Subject: SAFETY RECALL NOTICE
Recall No. 06C-004
Britax® Marathon™ Child Restraint
Model Numbers: E9L06, E9W06, and E906
Manufacture Dates: May 23, 2006 – July 28, 2006

SAFETY RECALL NOTICE

Recall No. 06C-004

Britax® Marathon™ Child Restraint

Where to look:

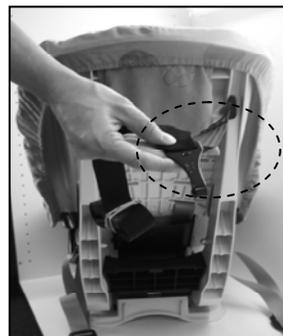
2. Does your top tether hook have lot number **KGR 01 A**?
 - If YES, refer to the instructions for the top tether hook replacement included with this notification.
 - **If NO, your model is not affected by this safety campaign, no action is required.** You may discard the top tether hook replacement included with this letter.

If your child restraint is involved in this safety notice, the top tether should not be used with children weighing over 50 pounds until the top tether hook replacement has been installed. Once the new top tether hook has been installed, place the provided "Do Not Use" label on and discontinue use of the existing top tether hook with lot number KGR 01 A.
